YEAR 3 MONITORING REPORT

ROSES CREEK STREAM MITIGATION SITE

Burke County, North Carolina
NC DMS Project # 96309

RE: NCDEQ – Division of Mitigation Services
Roses Creek MY 3 Monitoring Report
DMS Project Number: 96309
Response to DMS Review Comments on Draft Year 3 Monitoring Report for Roses Creek

CURRENT CONDITIONS PLAN VIEW (CCPV) YEAR 3

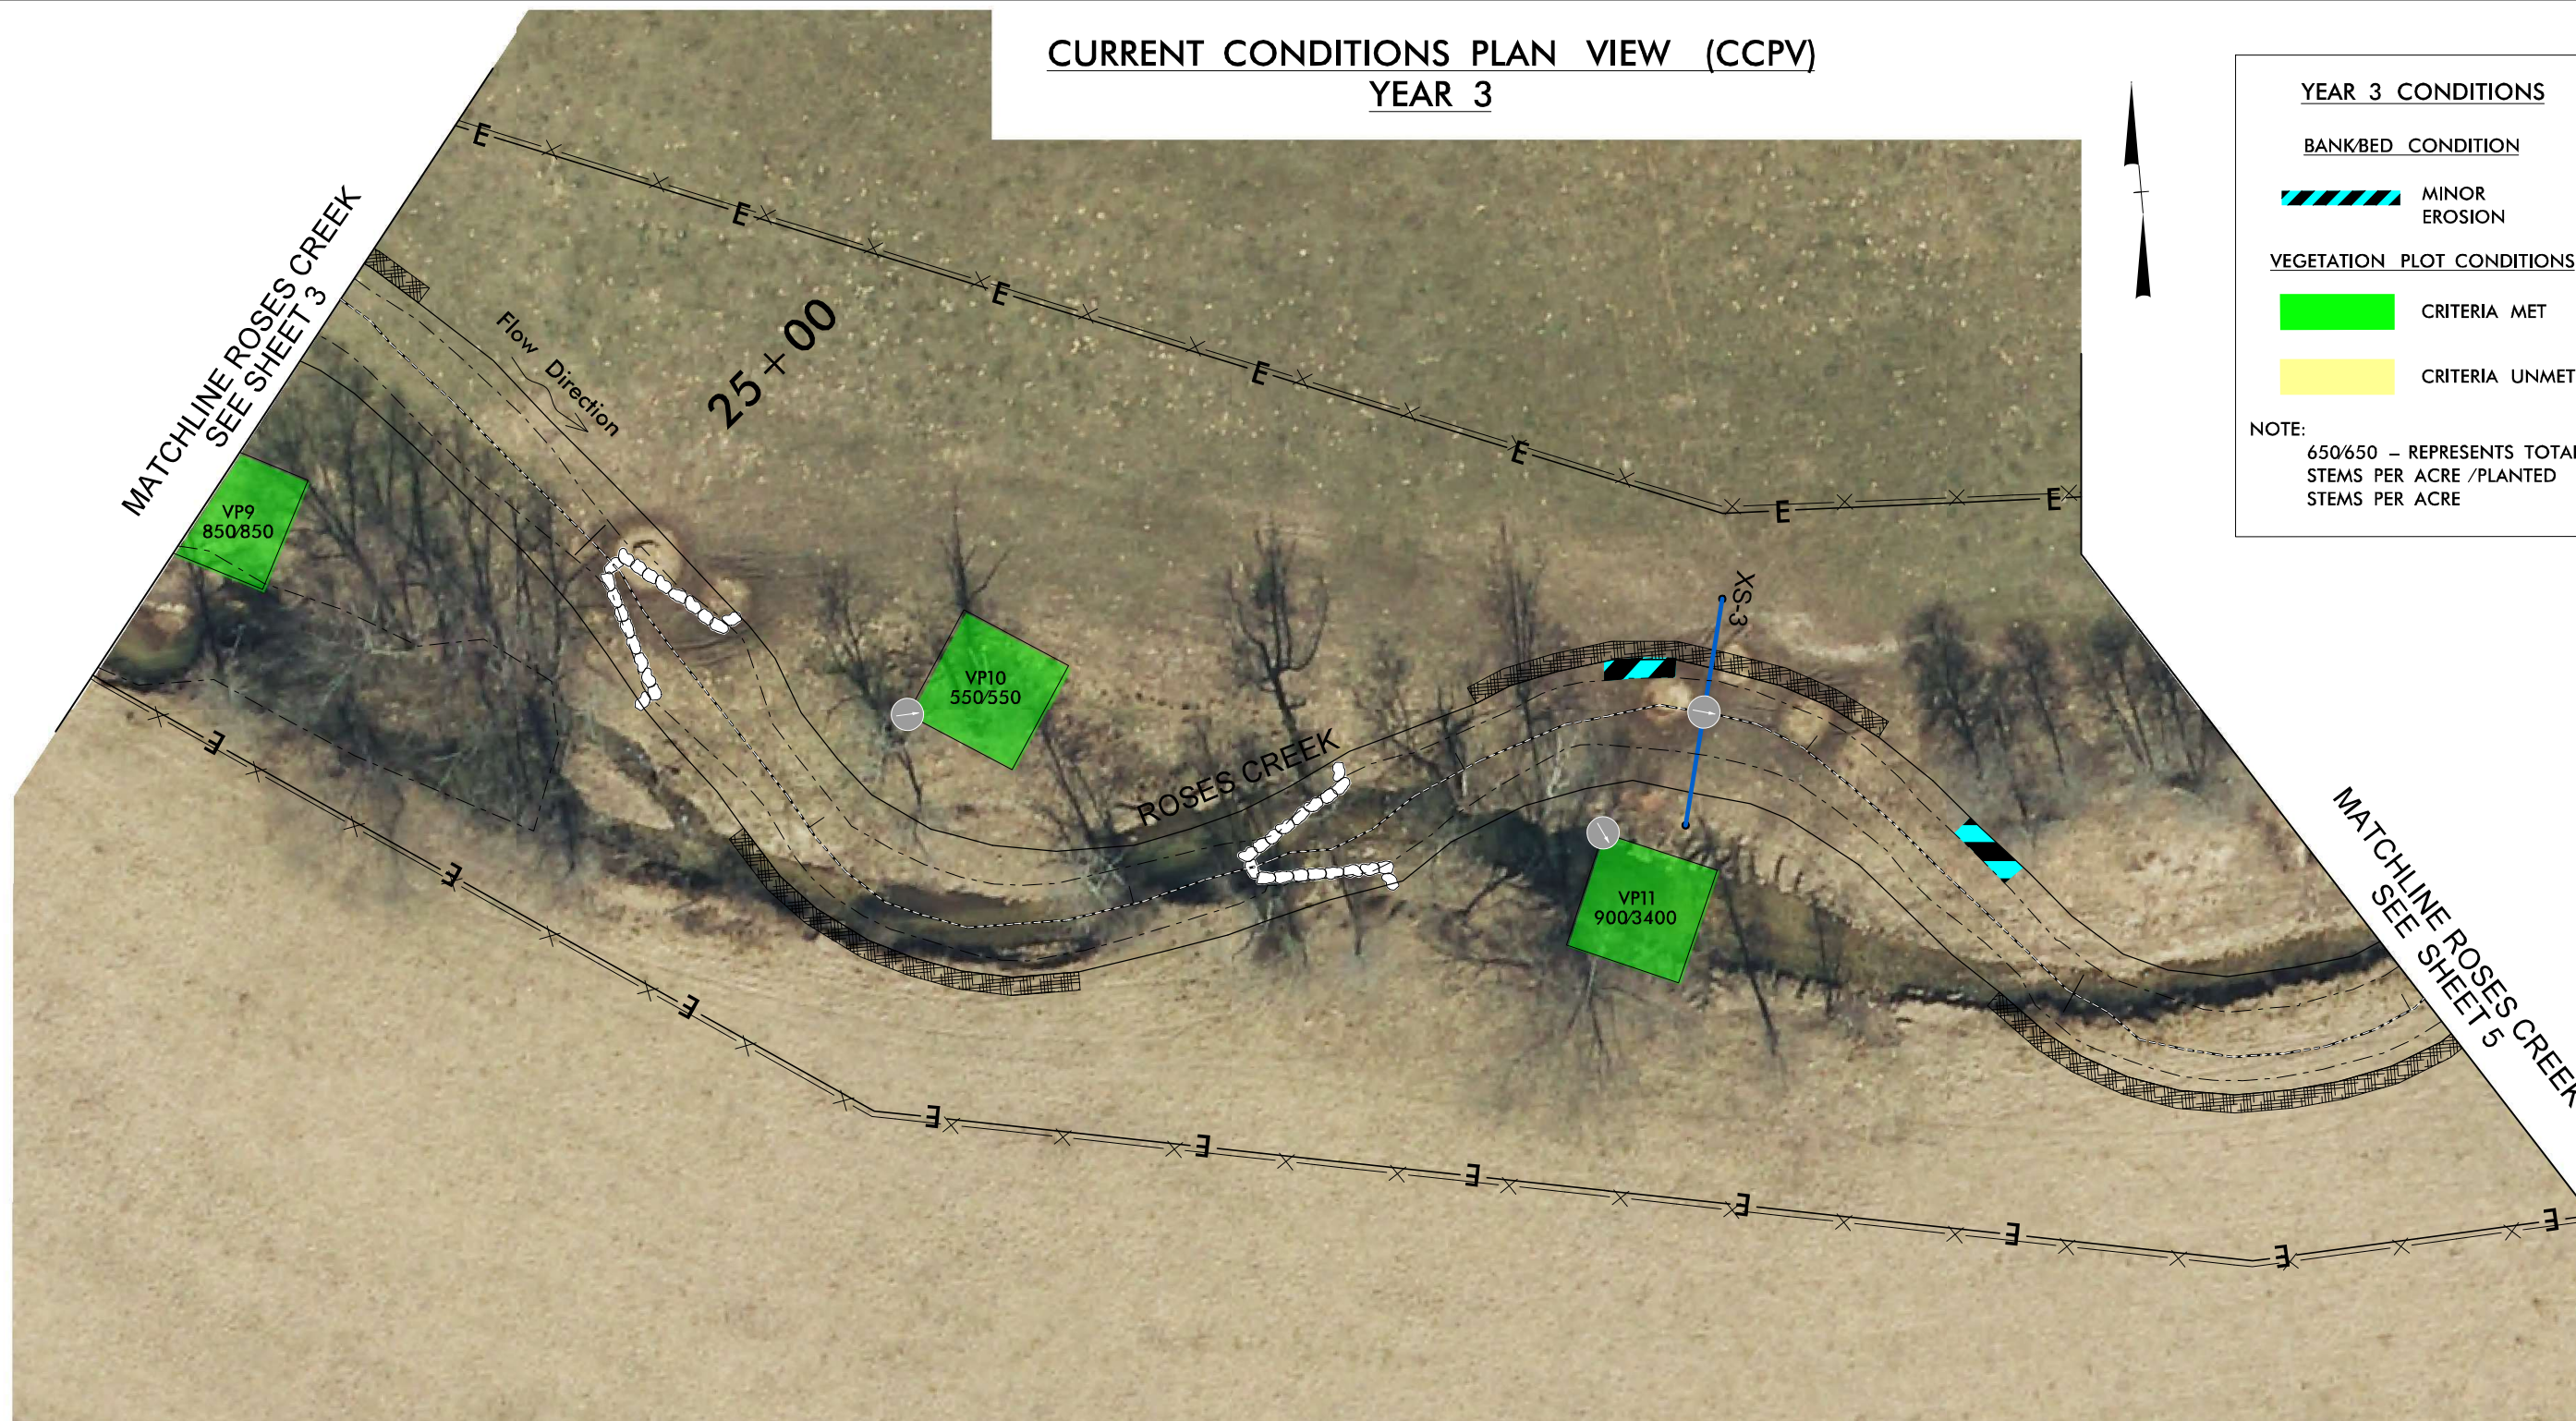
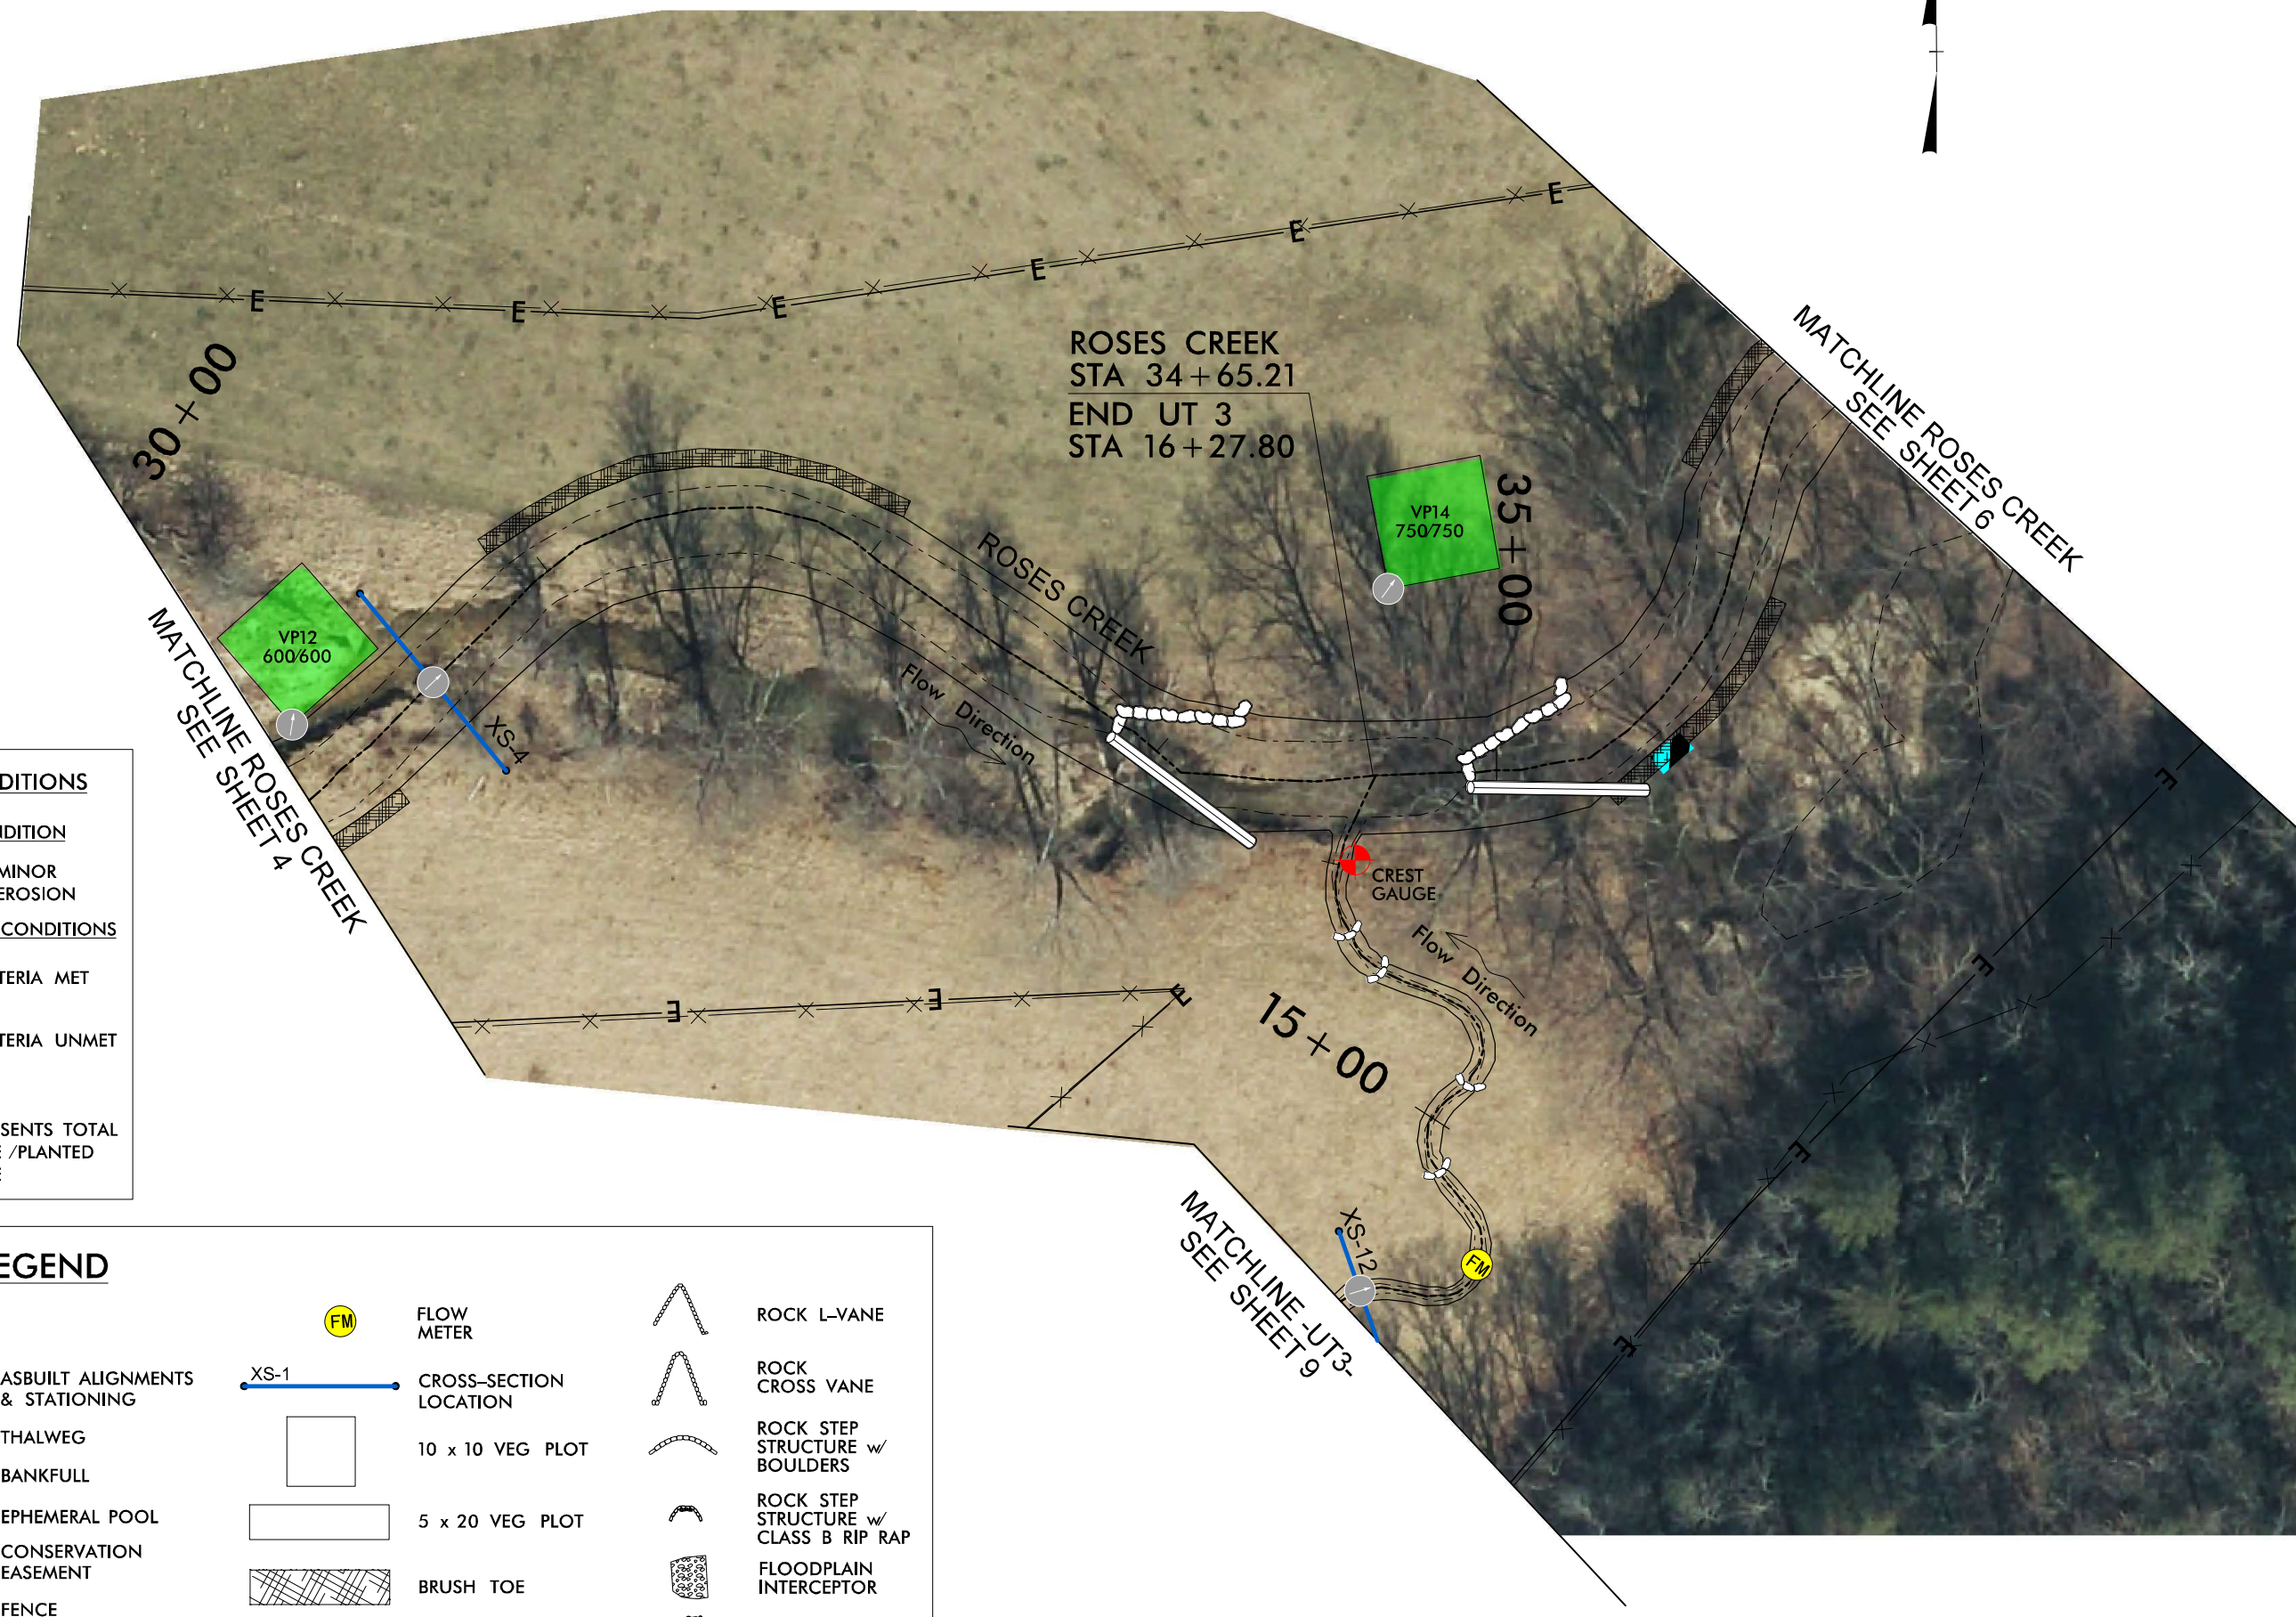
3. Please provide approximate locations of site issues / problem areas on the CCPVs; these were captured in 2017 but are not on the 2018 CCPVs. The mapped locations / areas presented in the narrative and tables should all be evident on the maps and mapped with as much detail as possible, including bare areas, silted reaches, erosion, invasive polygons, etc.

8. Update CCPV aerial, if available, to show restored stream alignment.

Response: The CCPV has been updated to show areas that are currently of concern. Many of the areas shown in 2017 were addressed during the repair work in October, 2018. A separate Adaptive Management Map has been included in the report in Appendix F. This figure shows areas that were repaired during 2018 and areas to be addressed in the near future.

Response: An updated aerial could not be located at this time.
